VTA's BART Silicon Valley Phase II Extension Project

CEQA Addendum to the
2018 Final Subsequent
Environmental Impact Report

Updated/Revised June 2024

Figure 1: Phase II Alignment Map
 VTA's BART Silicon Valley Phase II Extension Project

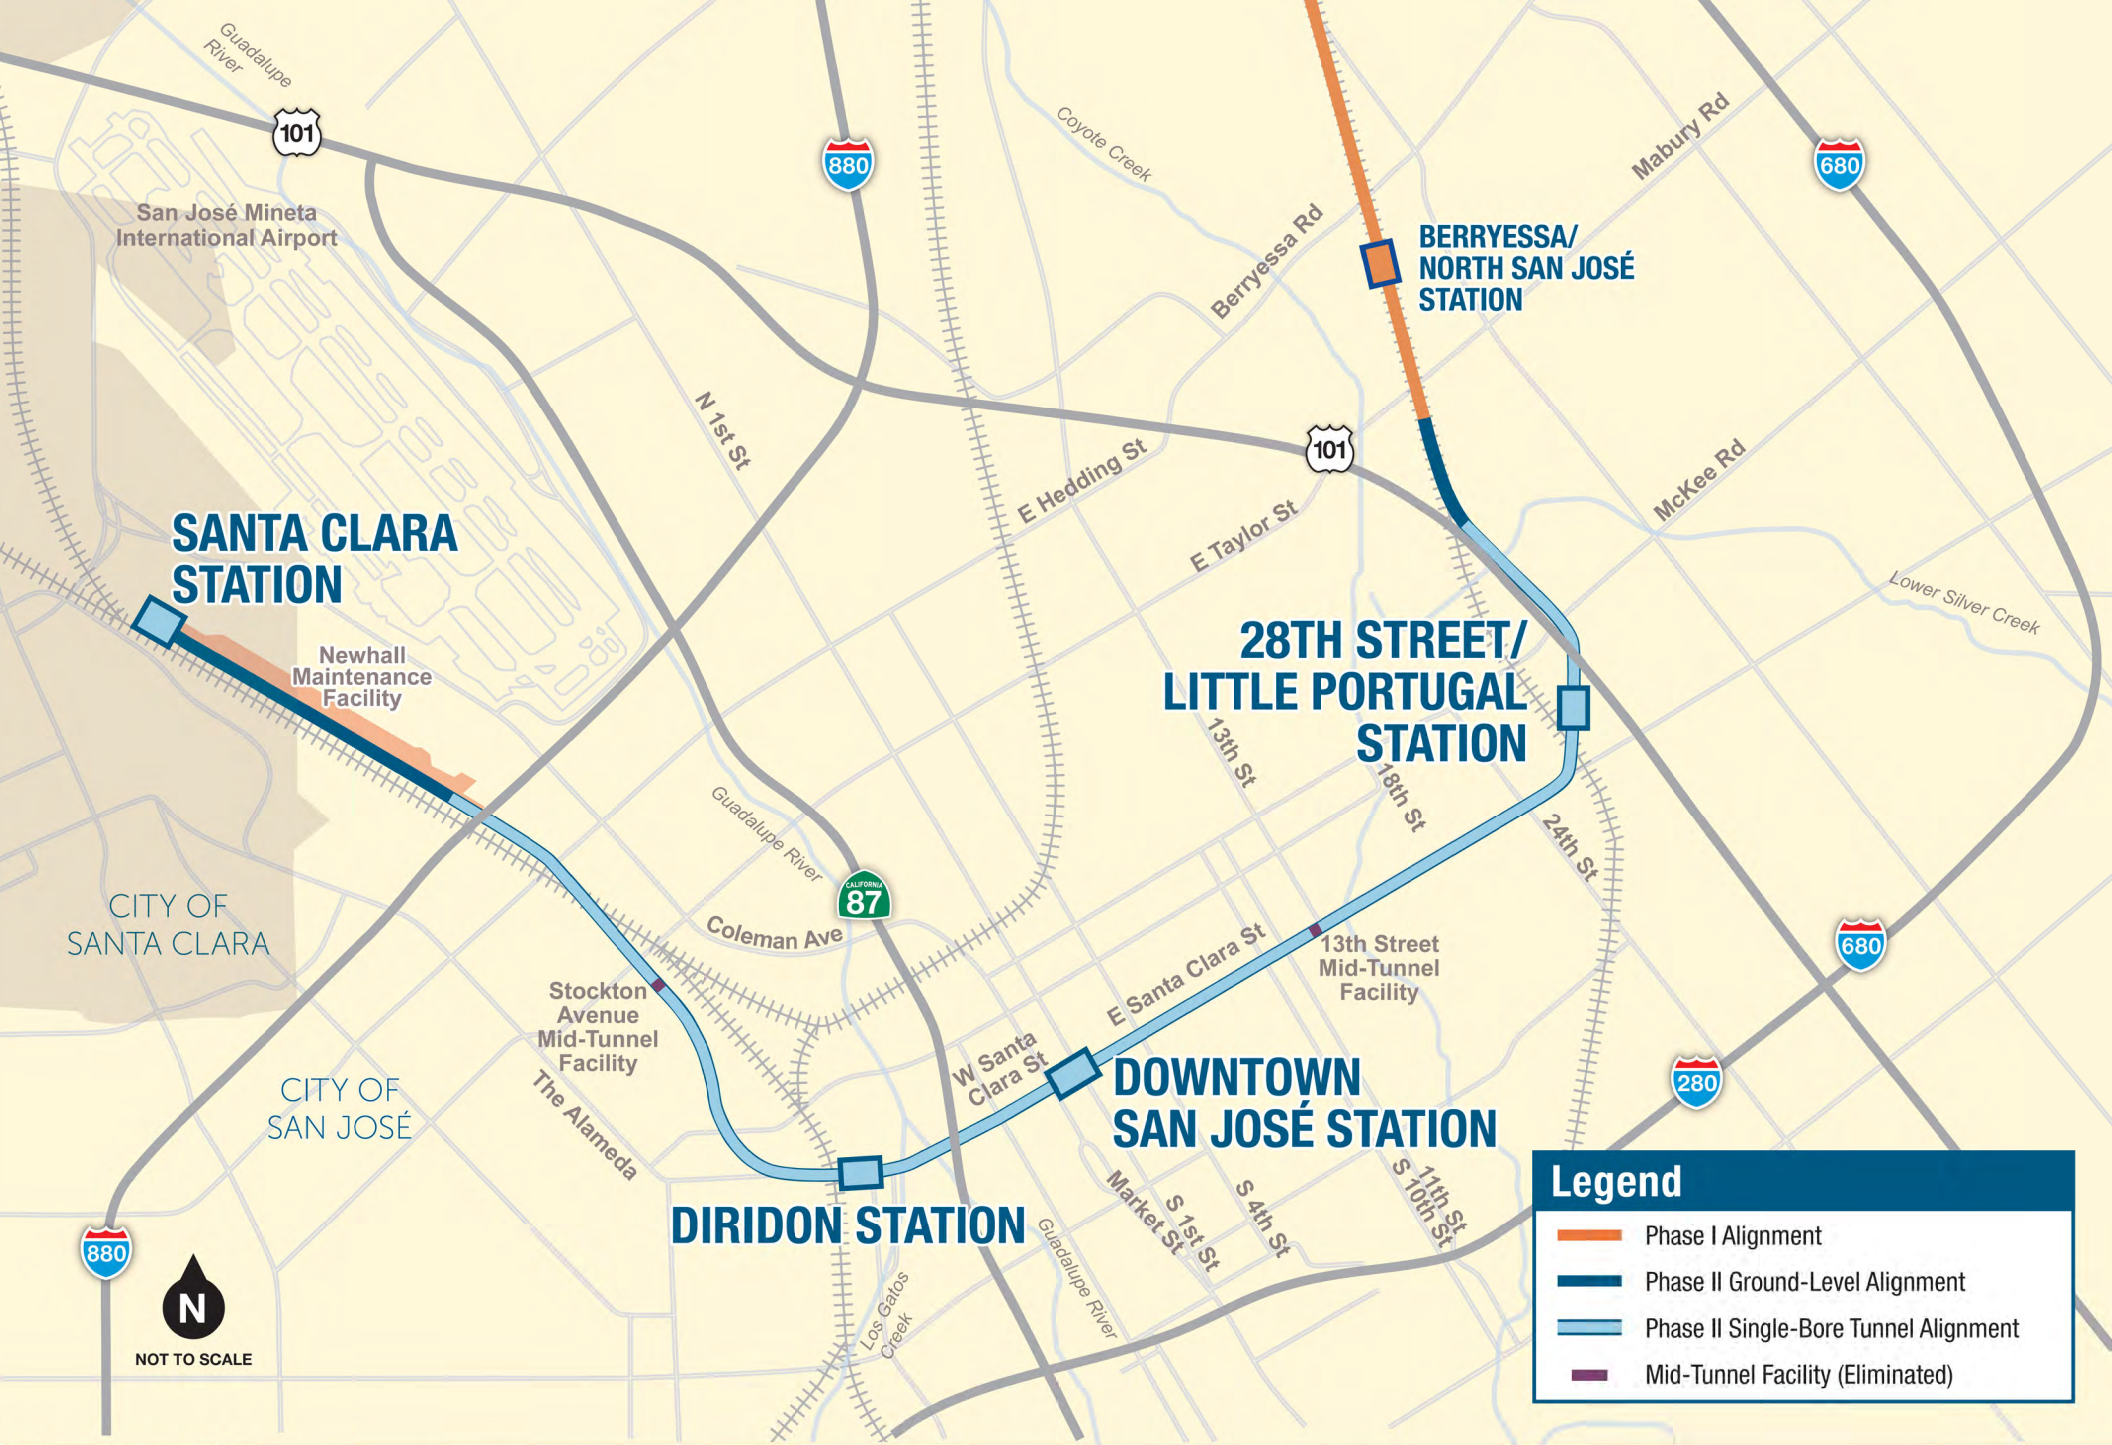
- **East Mid-Tunnel Facility at Santa Clara and 13th Streets.** The design refinements for the ventilation system would result in the elimination of the Mid-Tunnel Facilities (see Figure 1).

- **West Mid-Tunnel Facility at Stockton Avenue and Taylor Street.** The design refinements of the ventilation system would result in the elimination of the Mid-Tunnel Facilities (see Figure 1).

Figure 2: Single-Bore Tunnel Station Configurations
 VTA's BART Silicon Valley Phase II Extension Project

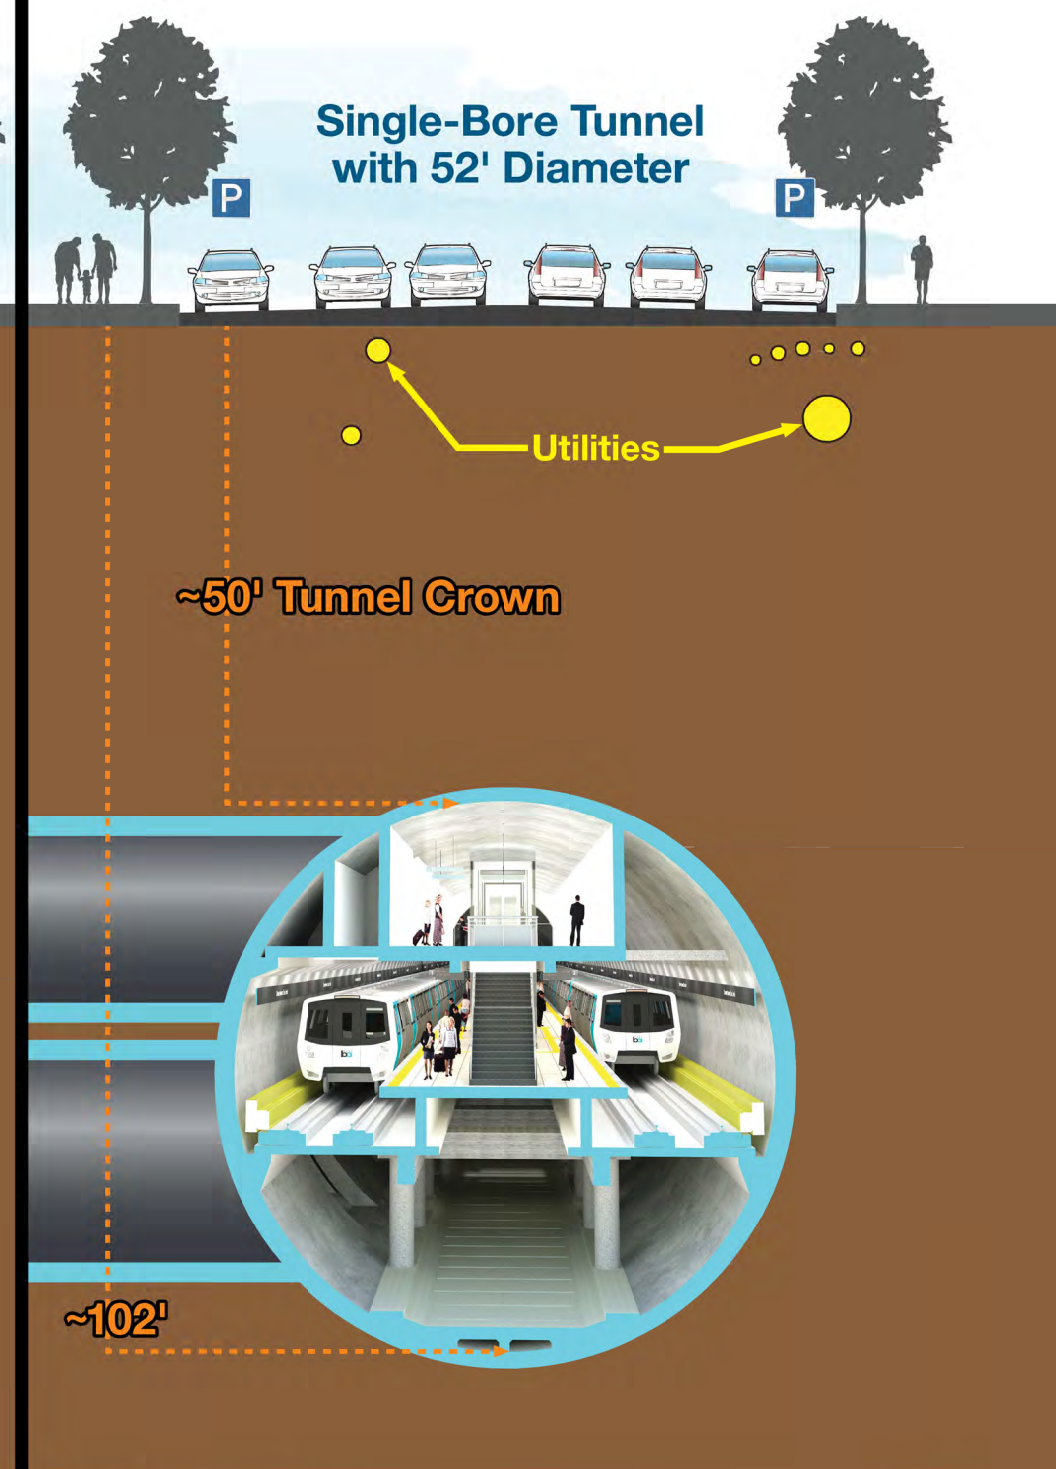
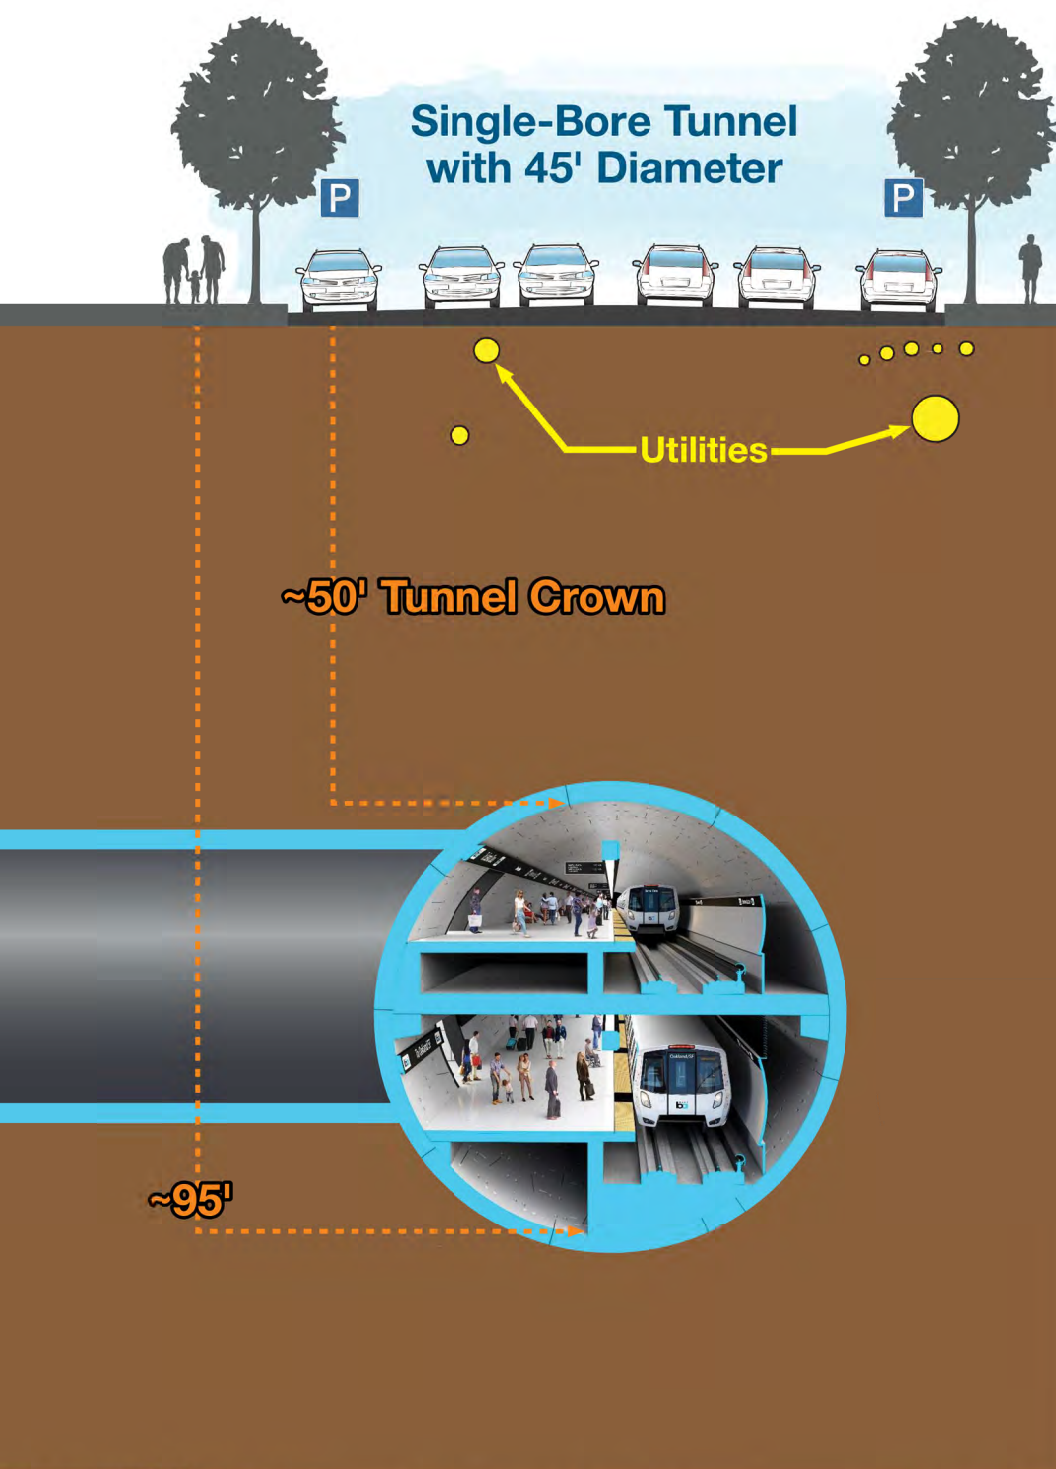
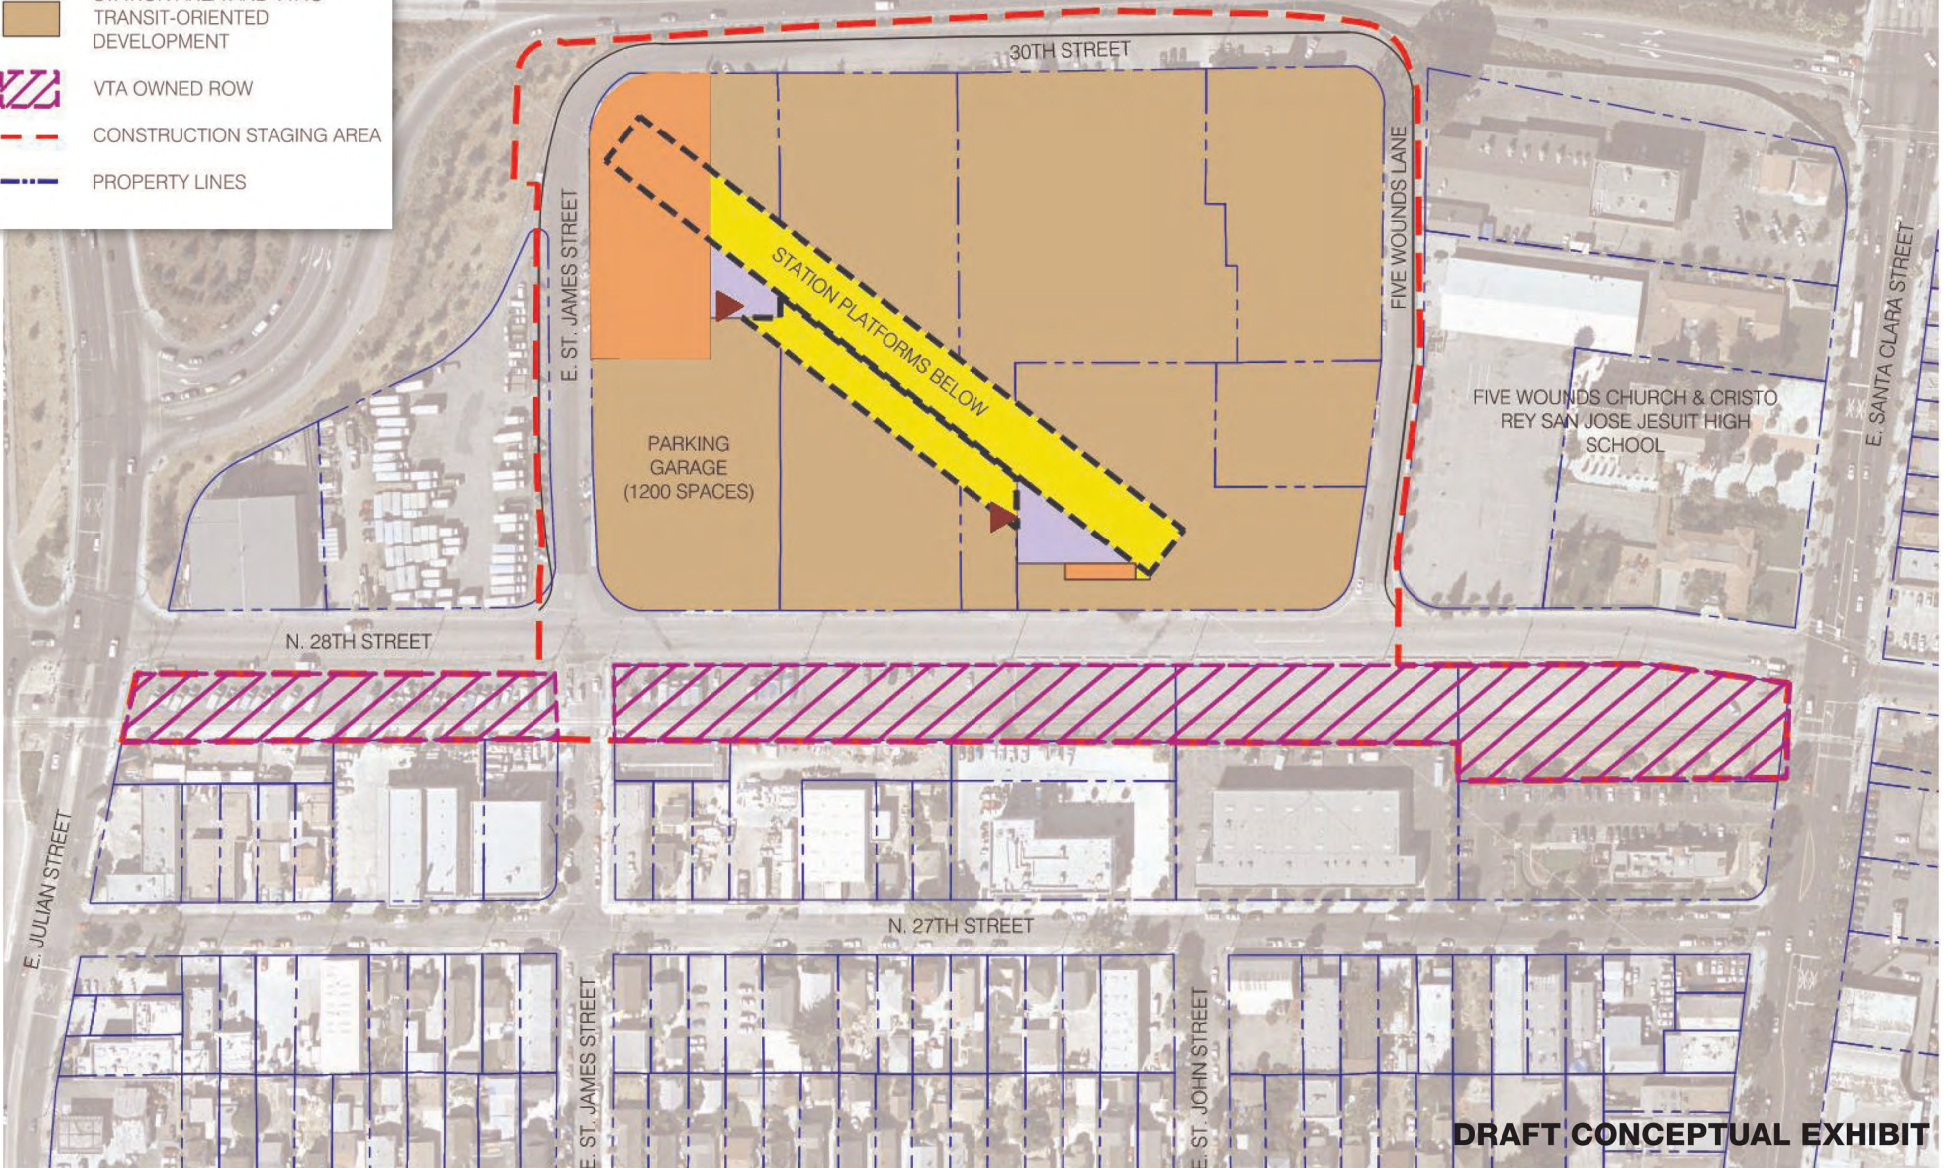
Since the project was approved in 2018, the design of the single-bore tunnel configuration has been further refined. To maintain minimum platform widths at the three underground stations and a consistent side-by-side track configuration throughout the entire alignment, as disclosed in the 2022 Addendum, the tunnel's inner and outer diameters would be increased from approximately 41 feet to 48 feet and 45 feet to 52 feet, respectively (see Figure 2). Also, there would be vertical alignment shifts (up to approximately 13 feet shallower and up to approximately 33 feet deeper) and horizontal alignment shifts of up to 125 feet at the widest diversion point (just west of Diridon Station) of the tunnel. These shifts are within the same project footprint evaluated in the Final SEIS/SEIR.

Figure 4: 2024 28th St/Little Portugal Station Conceptual Site Plan
VTA's BART Silicon Valley Phase II Extension Project

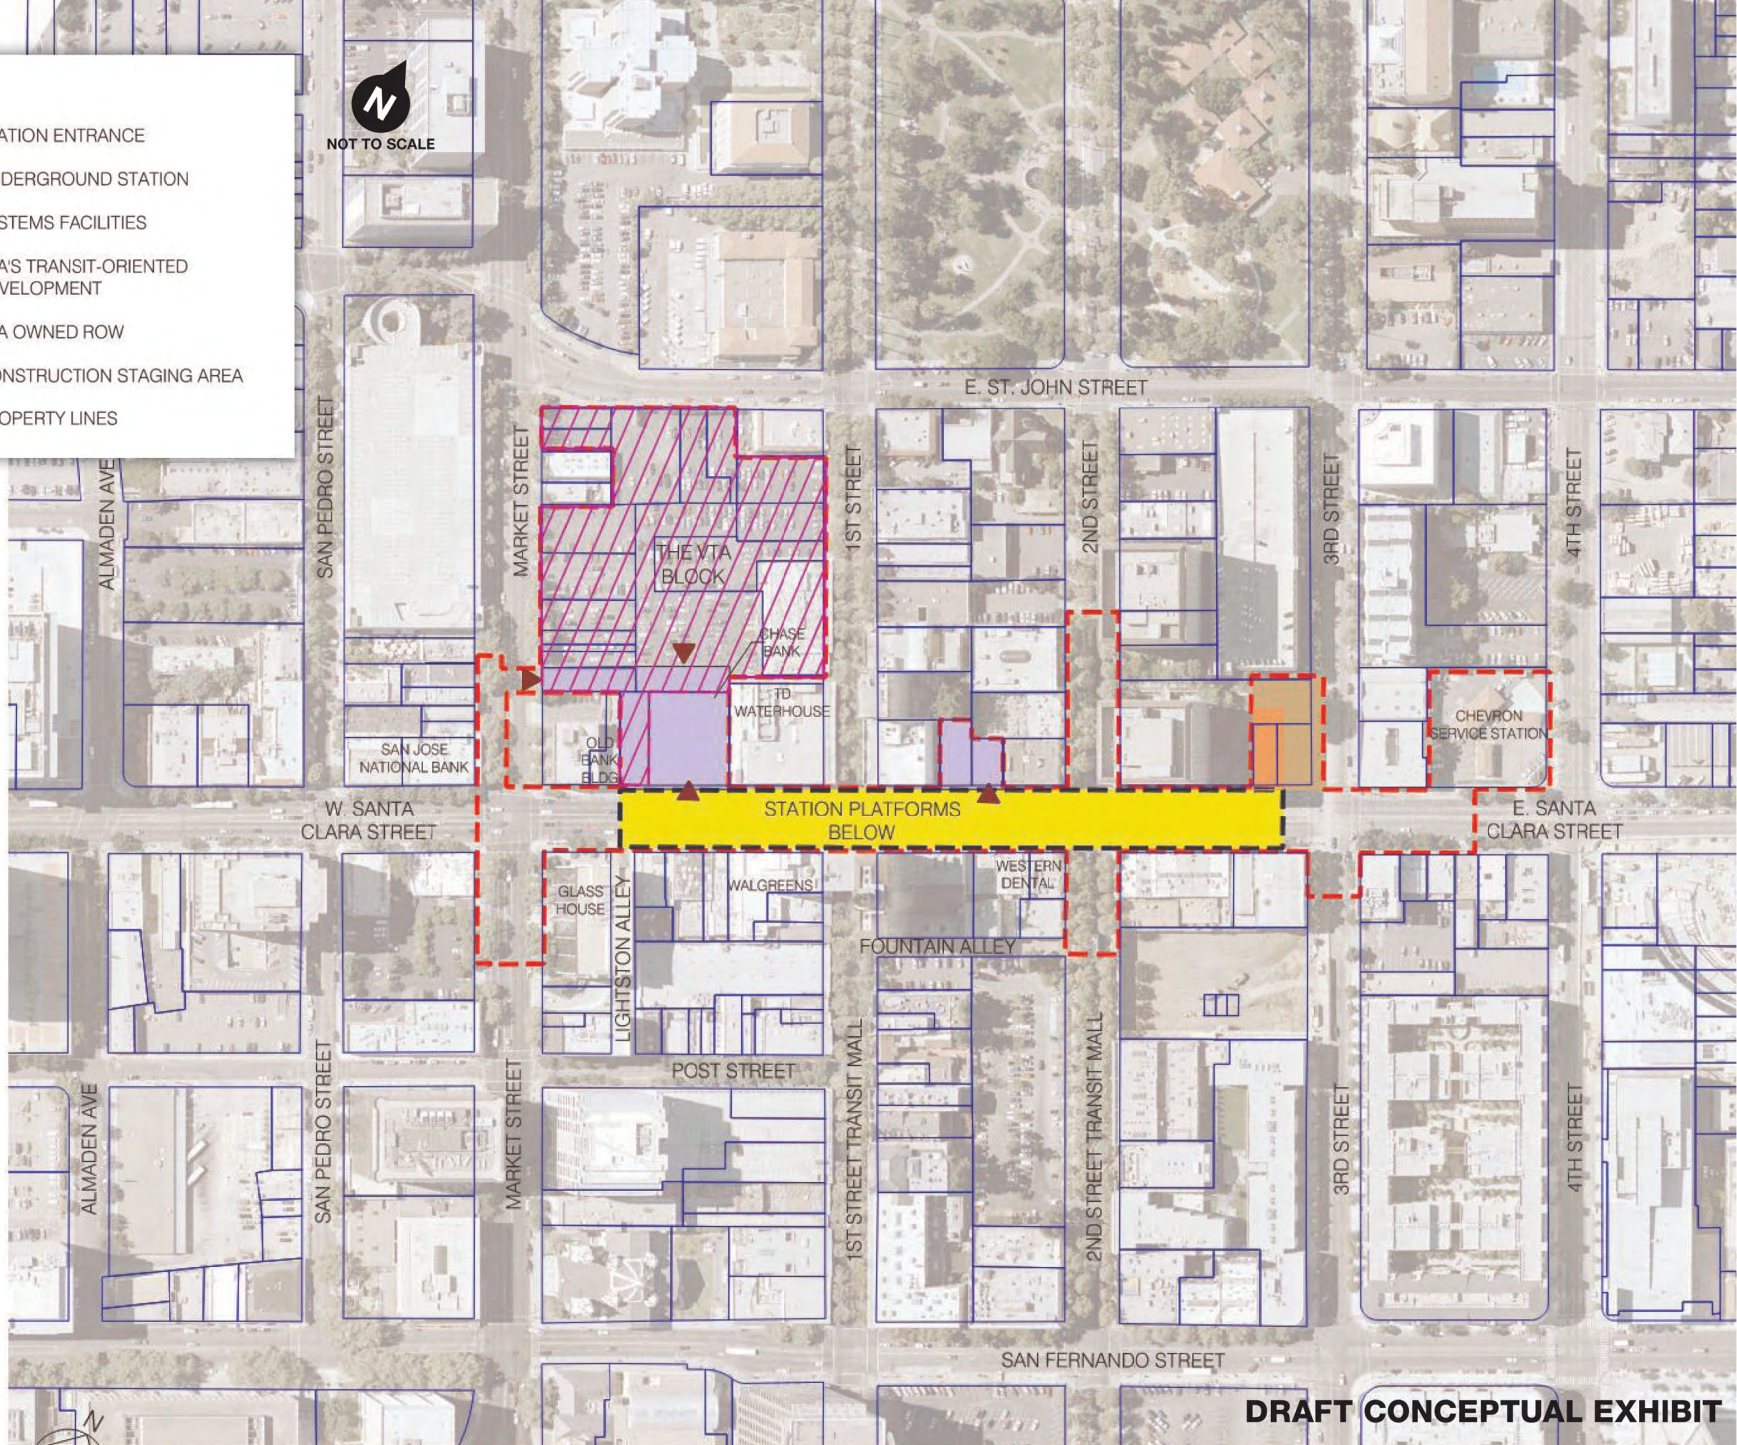
- **28th Street/Little Portugal Station.** This station includes the same project elements in generally the same locations as described in the Final SEIS/SEIR with the following minor modifications. In the Final SEIS/SEIR, this station included two separate entrance/exit portals located near each end of the station platform. With the updated design, the entrances would be consolidated into a single central station building, called a headhouse, that would have multiple street-level entrance/exit points. In addition, the parking garage shifted slightly from the northwest end near East St. James Street to the northeastern side near North 30th Street. Figures 3 and 4 show the previous and updated designs for this station. All design refinements are within the original station footprint.
